**SUBJECT: Invitation for Bids (IFB) 7-1904
"OC Streetcar Construction Project"**

This letter and its Attachments comprise **Addendum No. 6** to the above captioned Invitation for Bids issued by the Orange County Transportation Authority ("Authority").

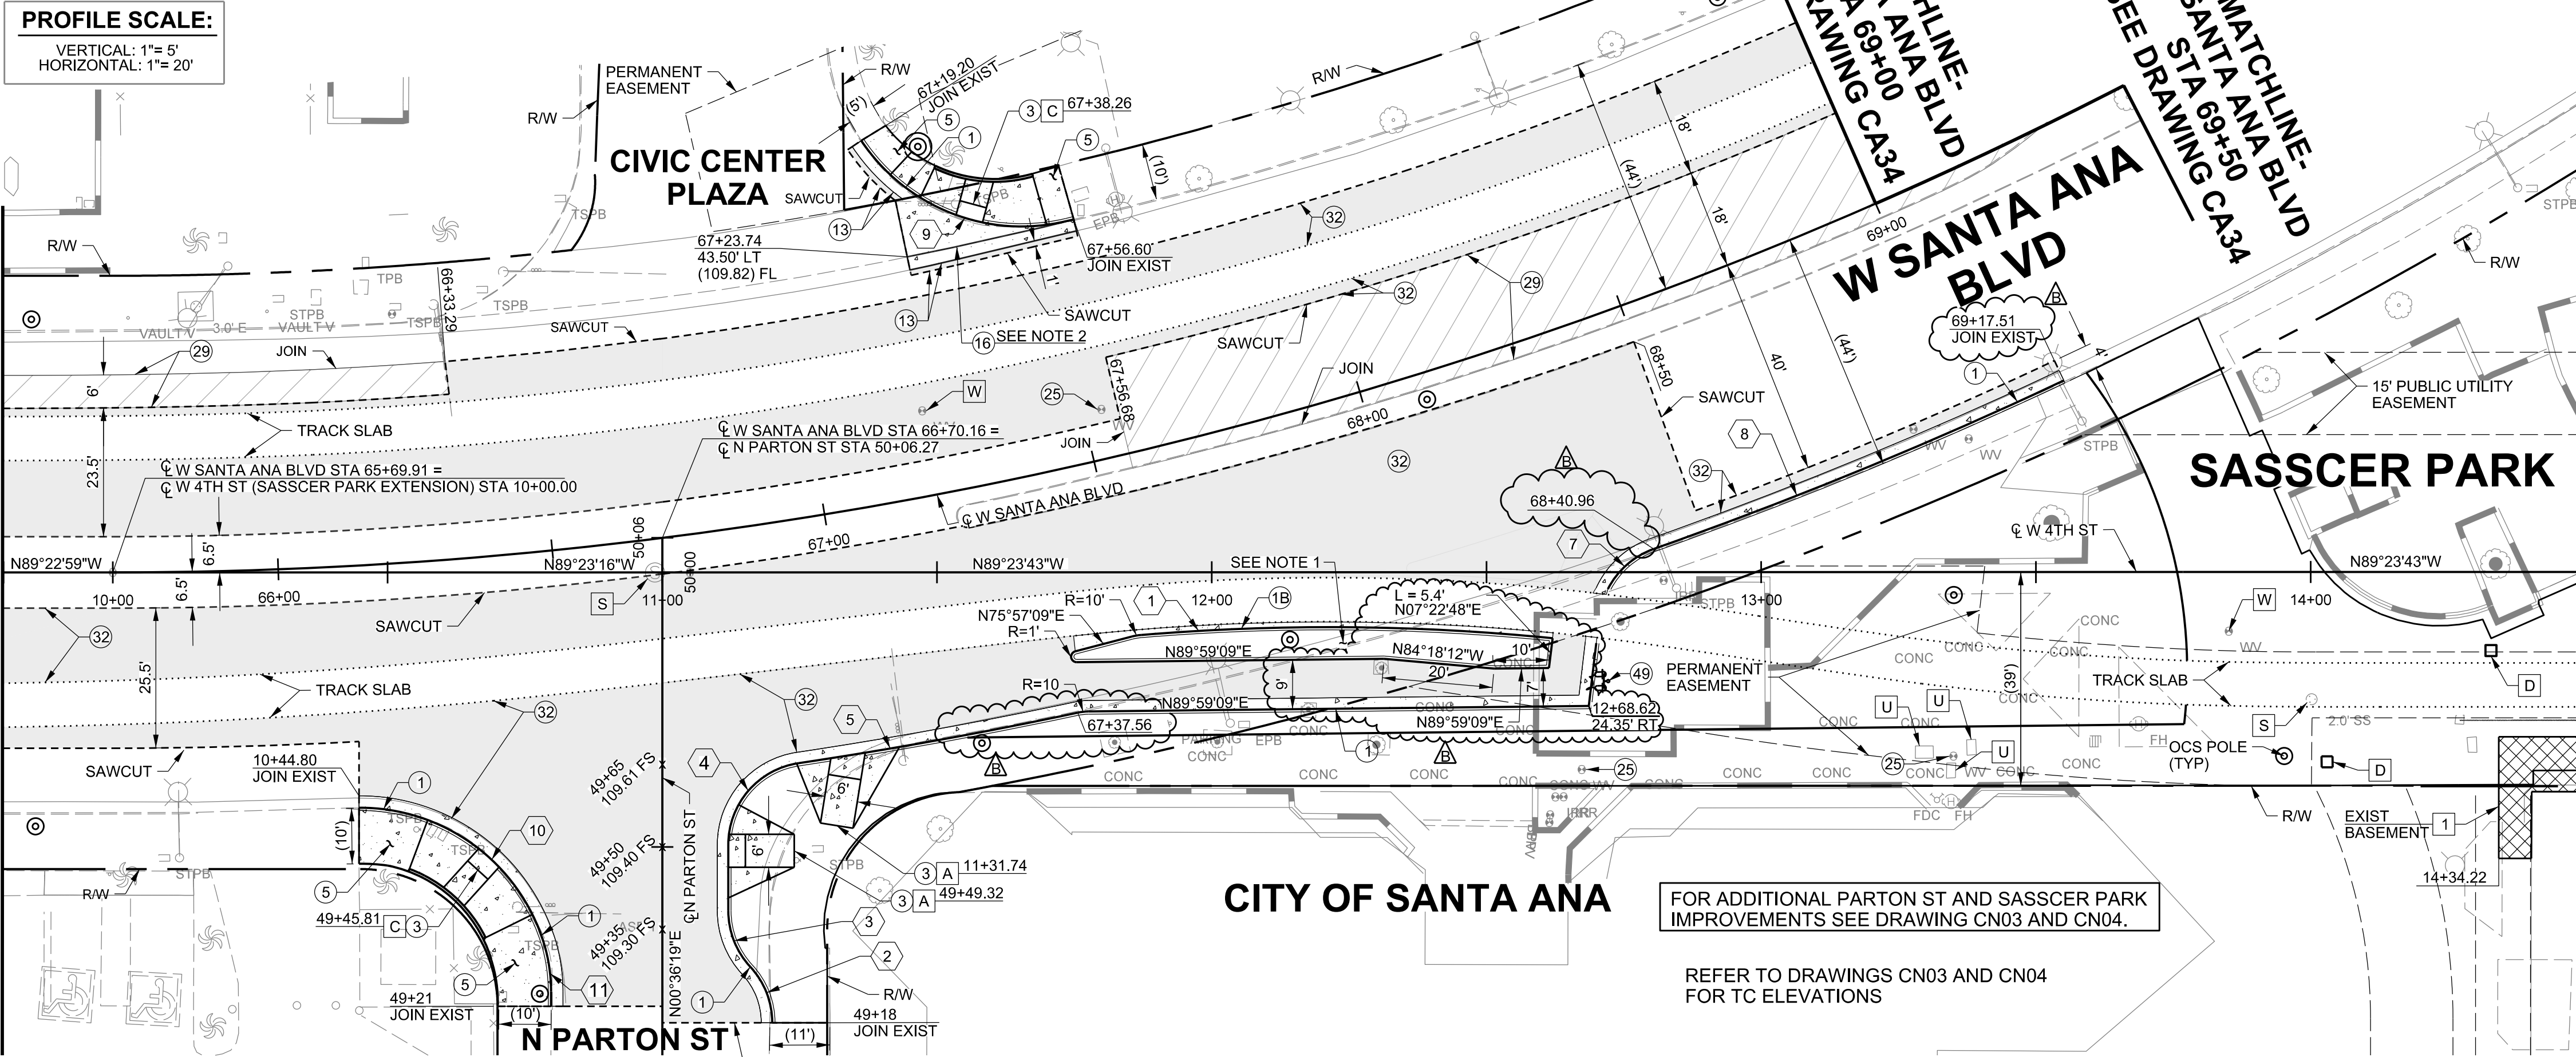
REVISIONS					
NUMBER	DATE	INITIALS	DESCRIPTION	APPROVED	INSTALLED
A	12/2017		ISSUE FOR BID		
Δ	02/22/18	JJV	CPUC - BIKE LANE - SASSCER PARK

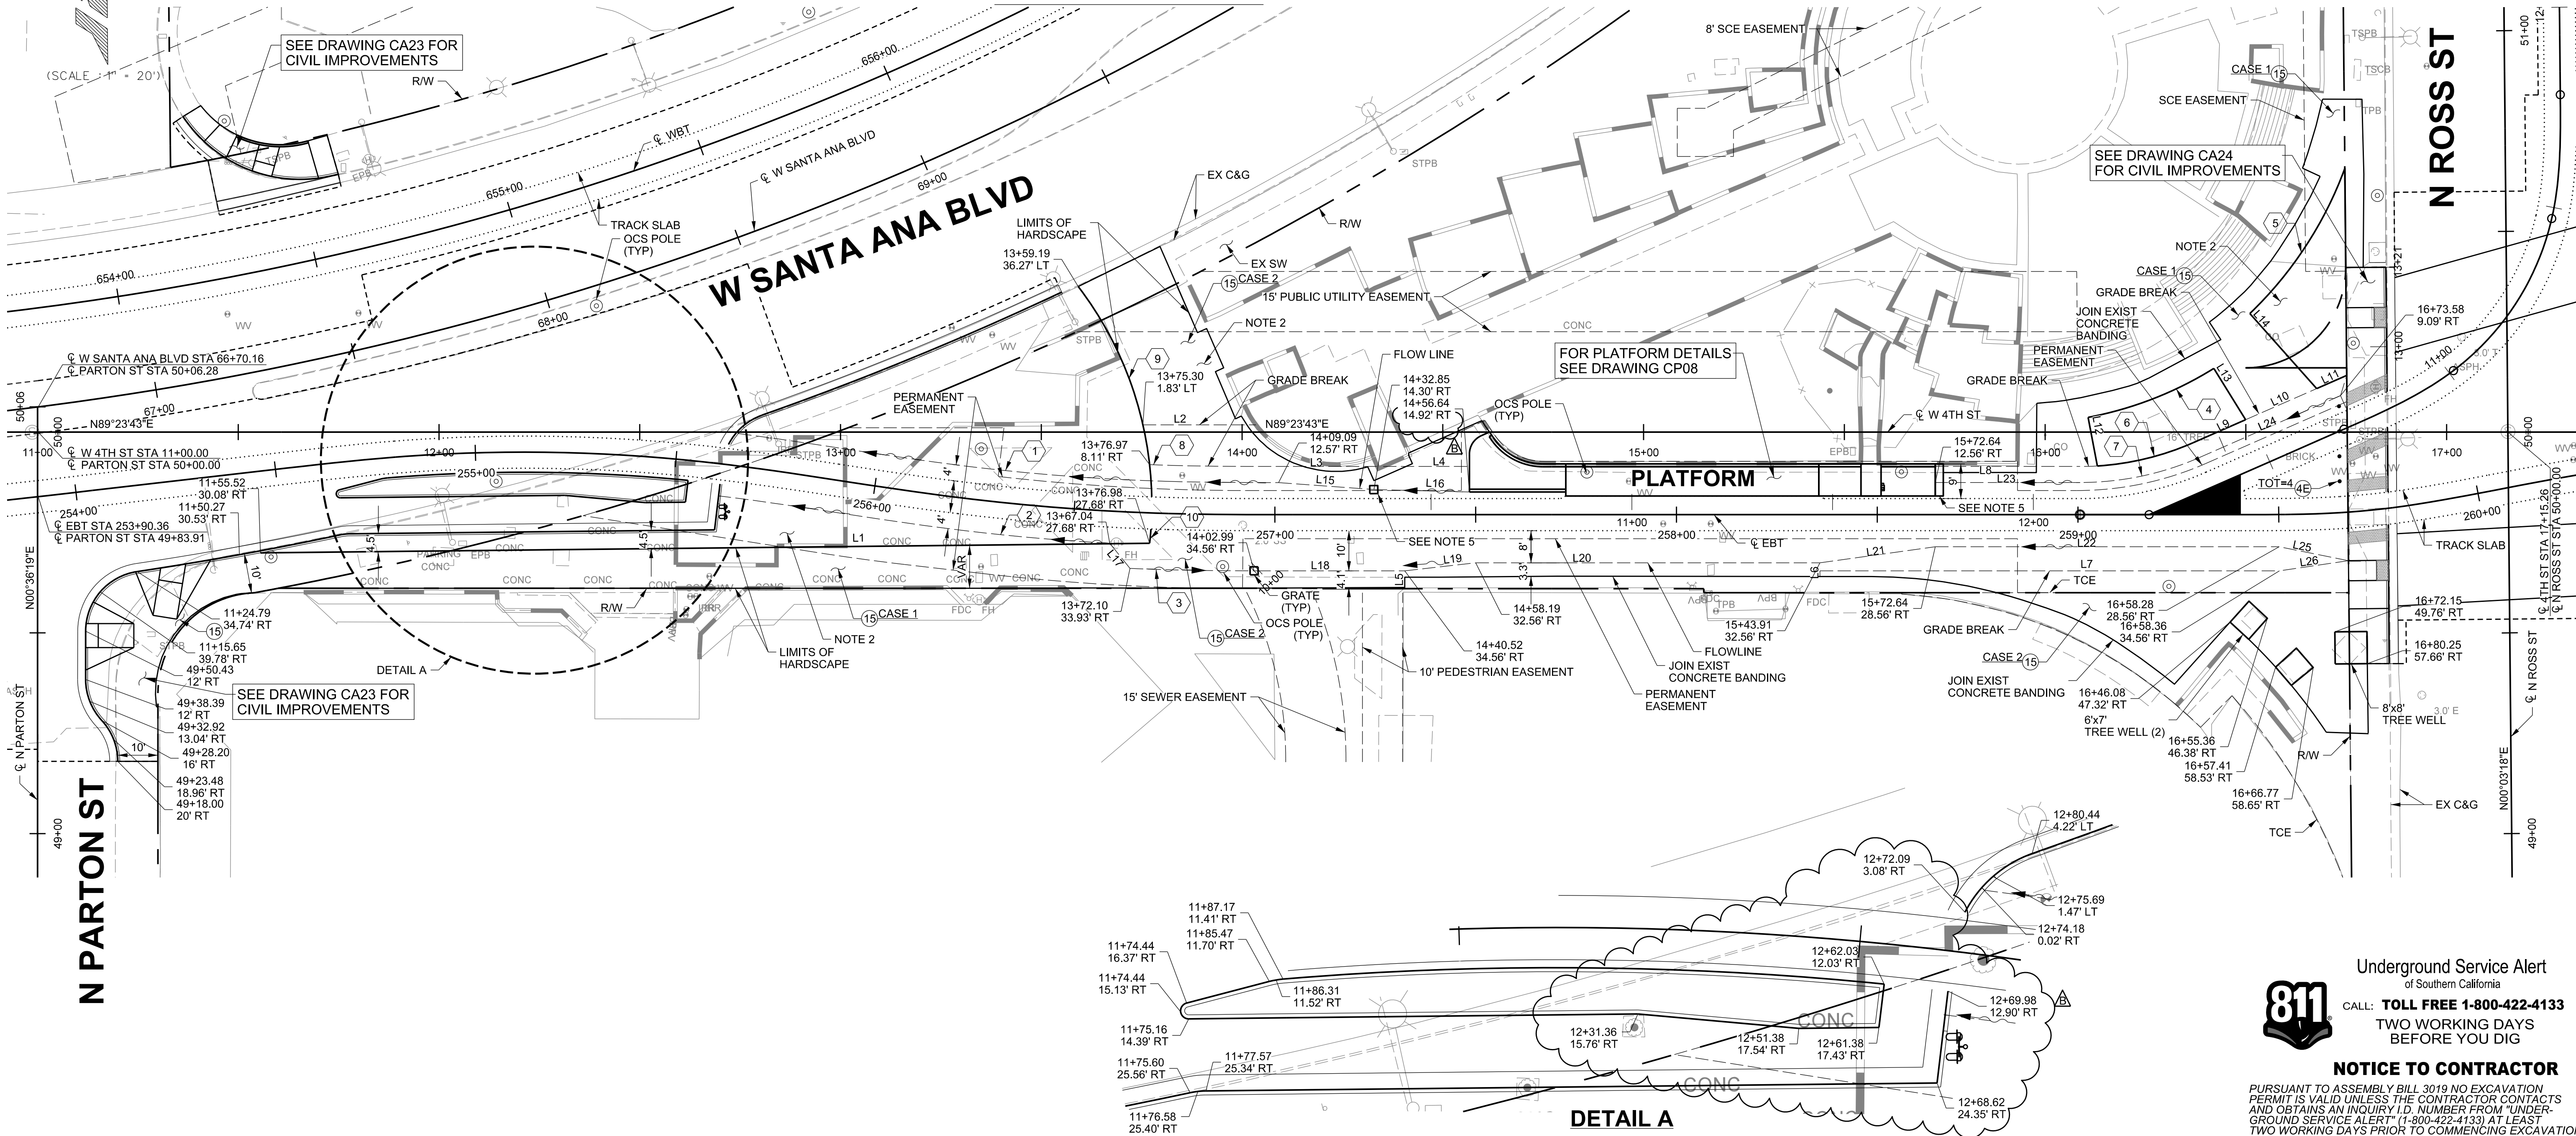
- ④E INSTALL RETRACTABLE BOLLARDS PER DETAIL DRAWING CD08.
- ⑮ CONSTRUCT CONCRETE SLAB FOR CONCRETE PAVERS PER DETAIL DRAWING CD08.

FN31

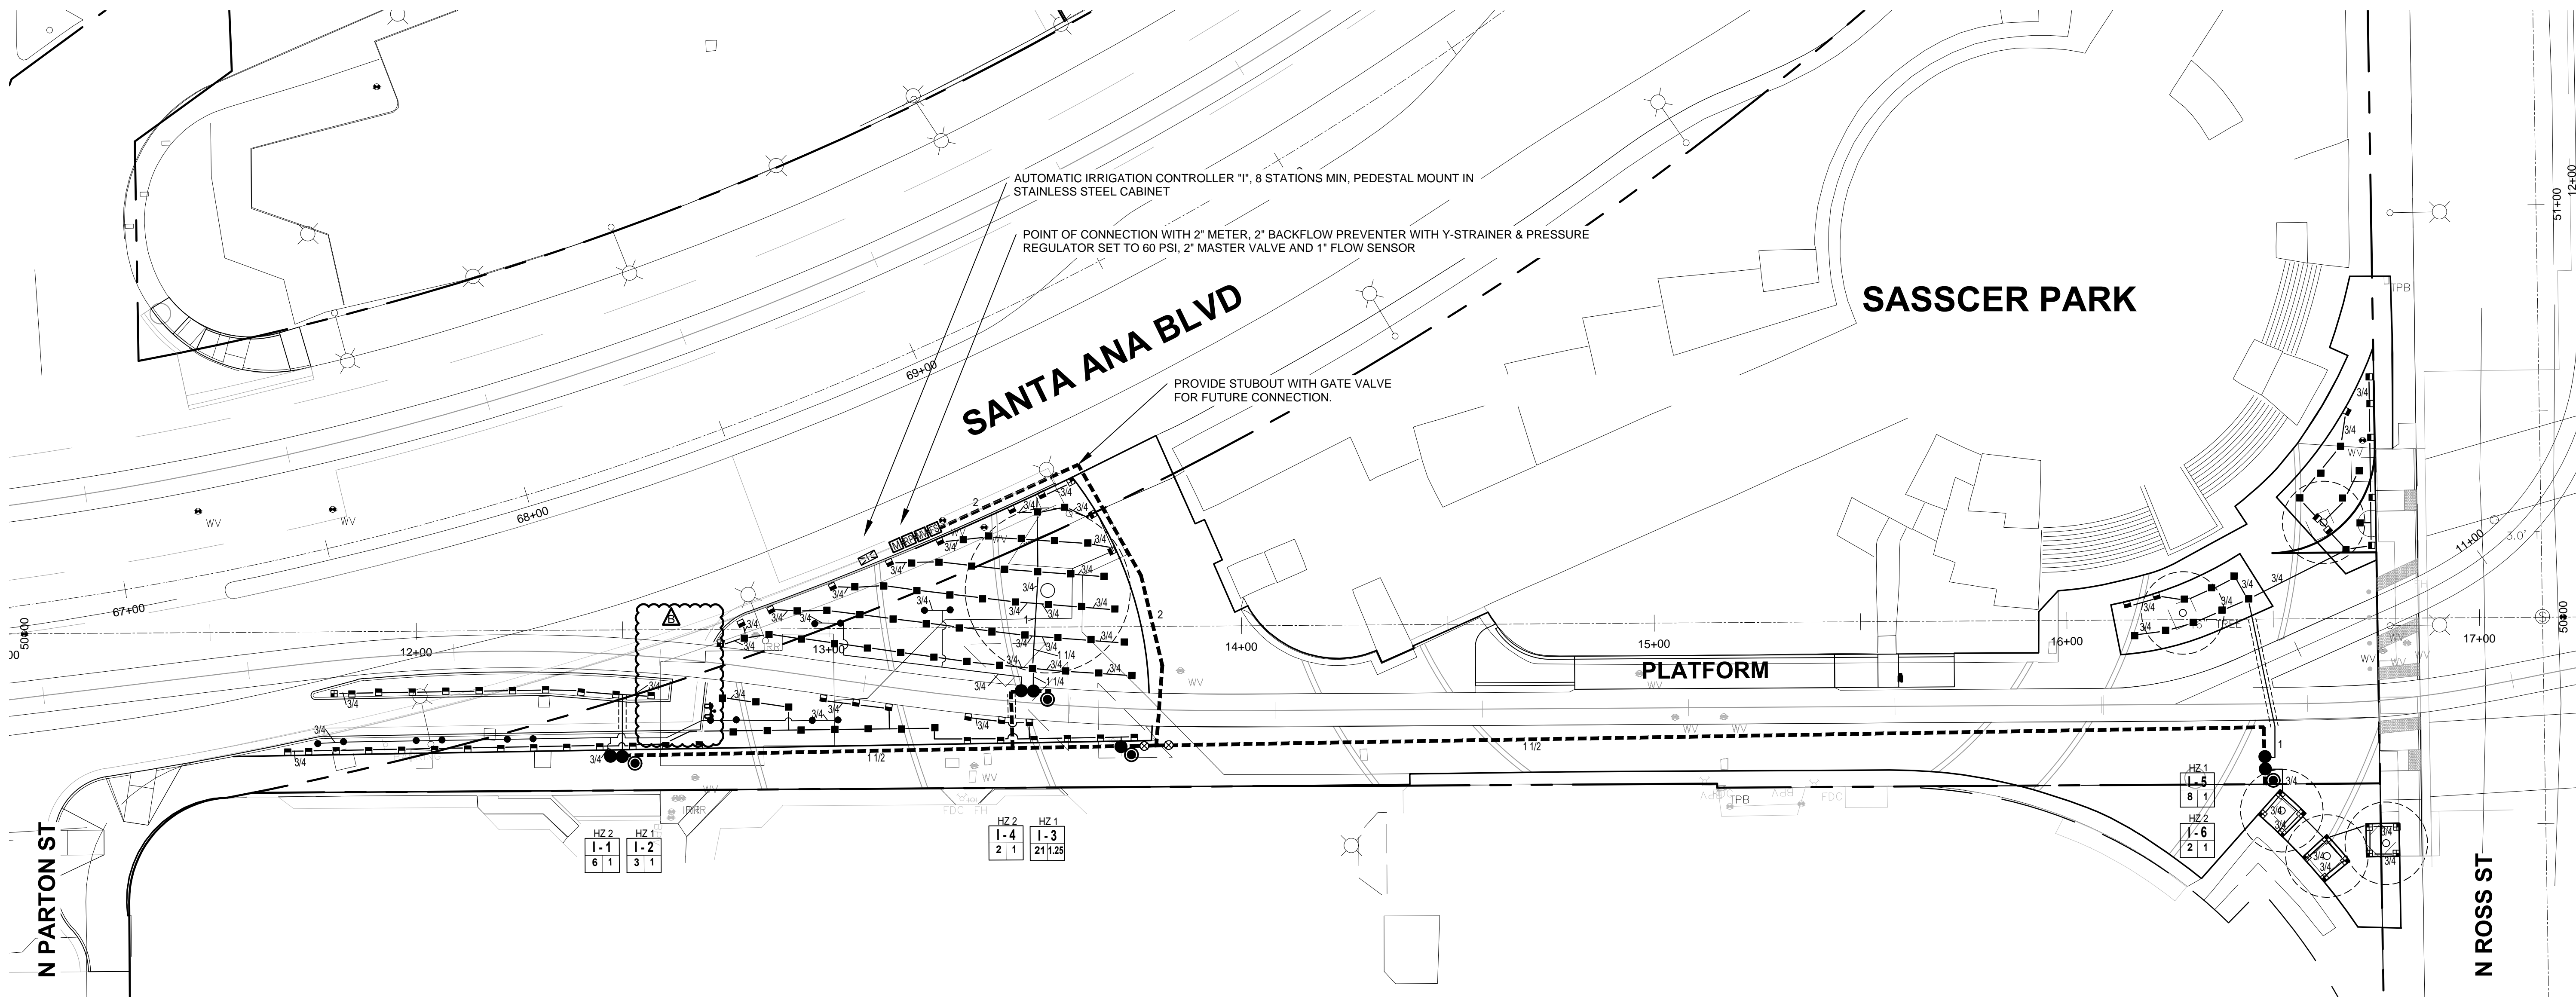
REVISIONS					
NUMBER	DATE	INITIALS	DESCRIPTION	APPROVED	INSTALLED
A	12/2017	ADZ	ISSUE FOR BID		
Δ	02/22/18	ADZ	CPUC - SASSCER PARK BIKE CROSSING

IN12

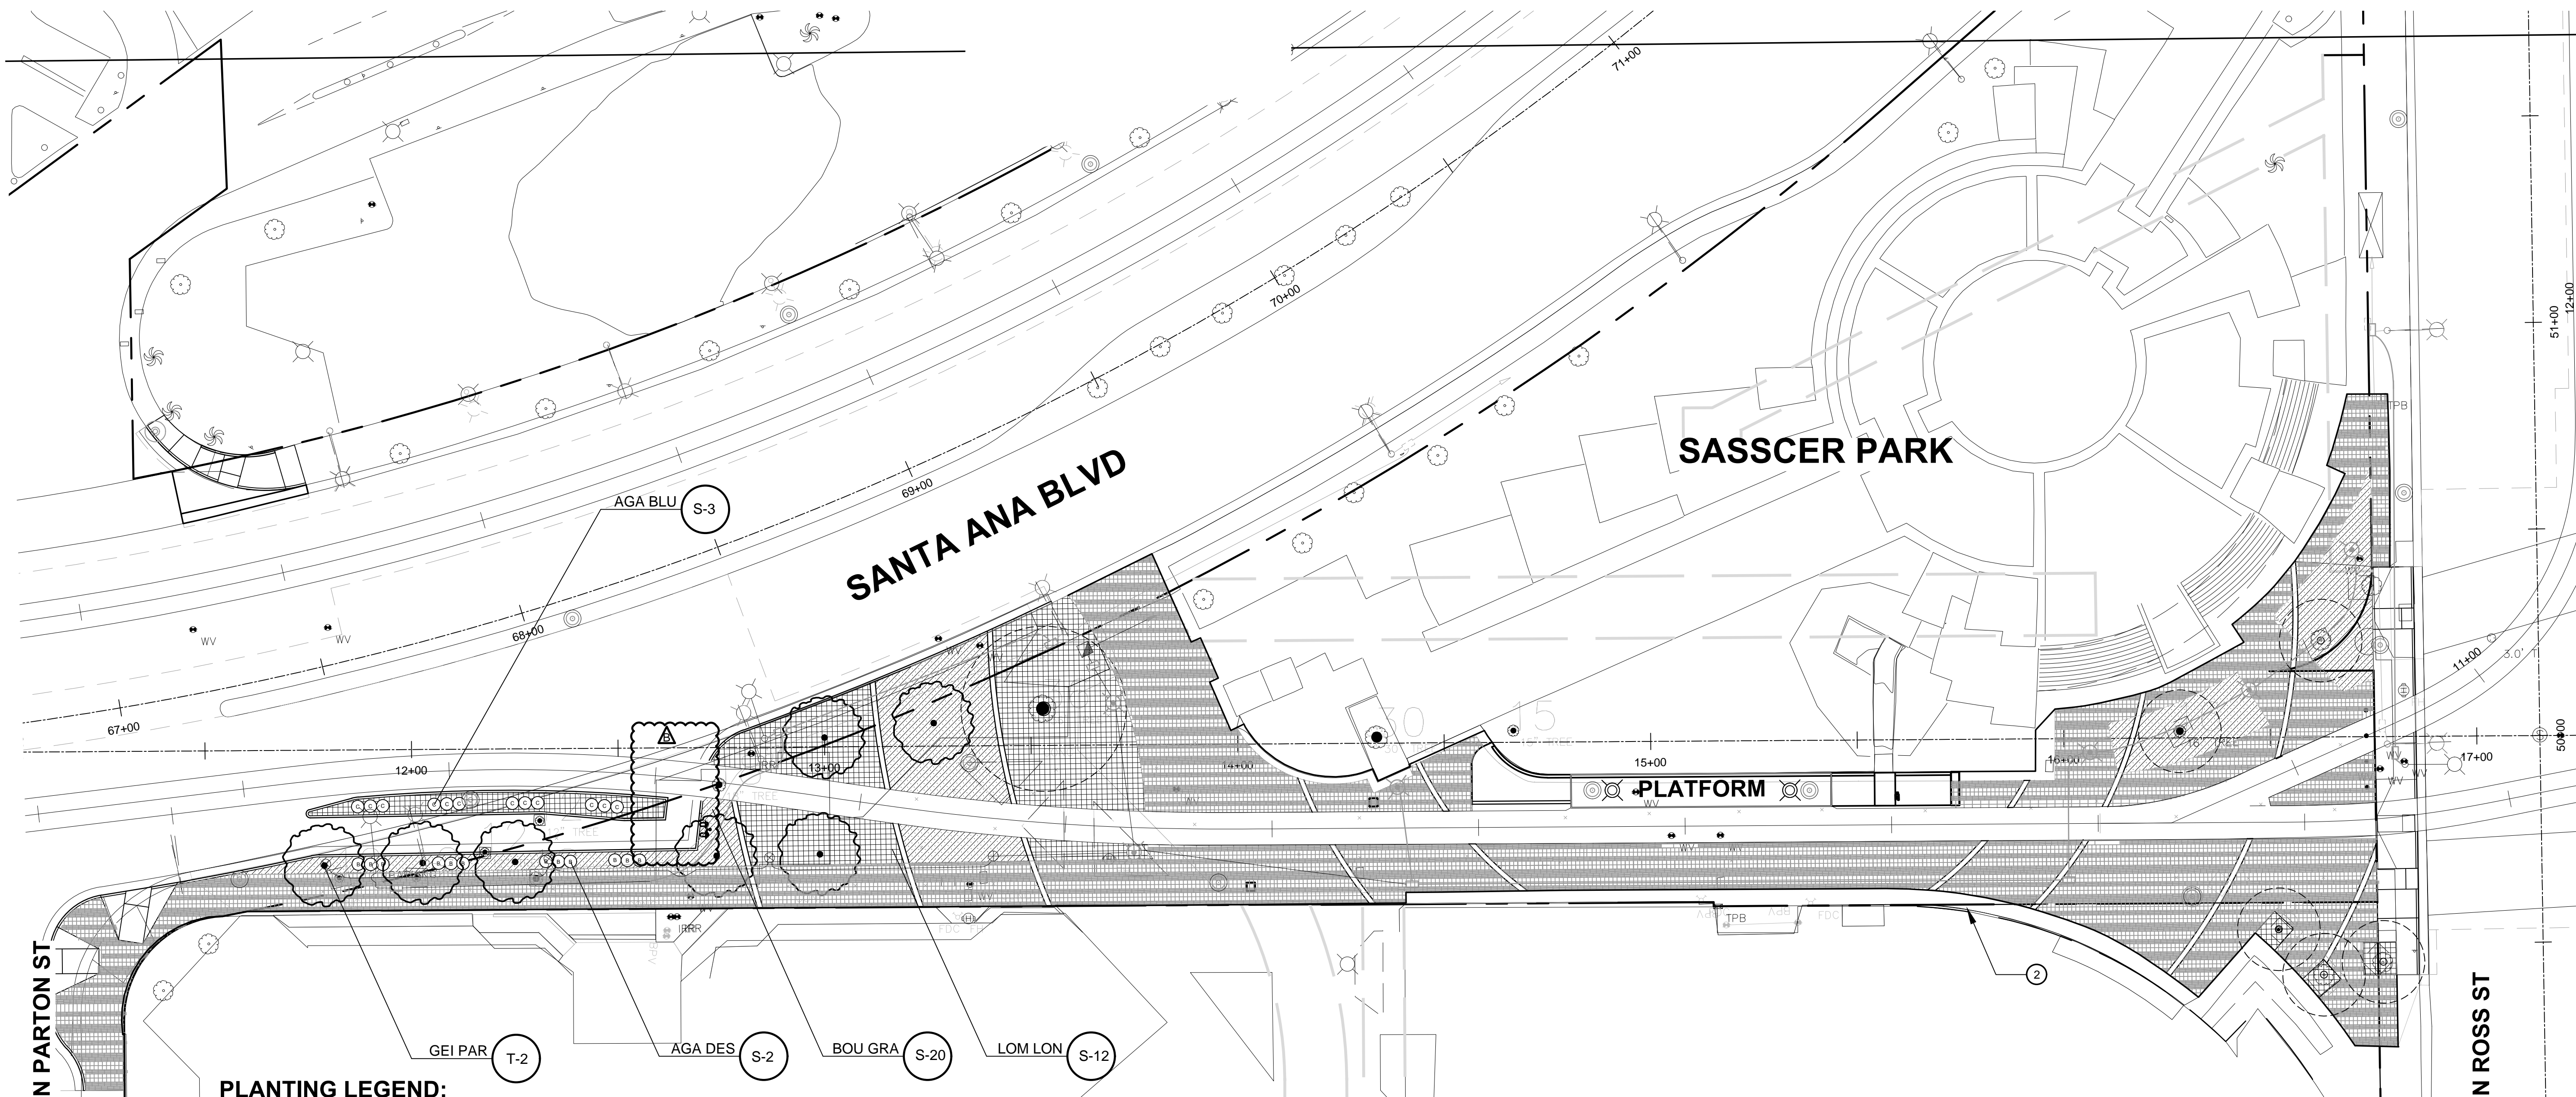
REVISIONS					
NUMBER	DATE	INITIALS	DESCRIPTION	APPROVED	INSTALLED
A	12/2017		ISSUE FOR BID		
Δ	2/22/2018	RW	CPUC - Bike Lane at Sassocer Park
